New probes for ScopeMeter.

Probes standard supplied with the 190 series.

From Oct. 18, 2000 all ScopeMeter 190's will be delivered with new improved probes (VPS200). The improvements are the ruggedness of the probe hookclip and the isolation of the industrial grabber.

VPS100

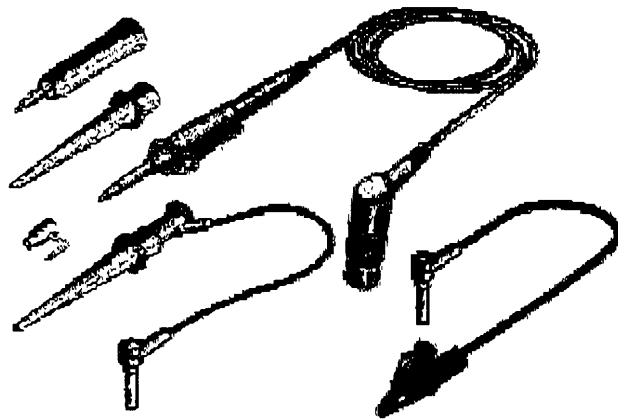
For ScopeMeter 90 series, replaces PM8918 probe series. Double insulated safety designed probe. Each probe set includes **600V CAT III / 1000V CAT II rated**
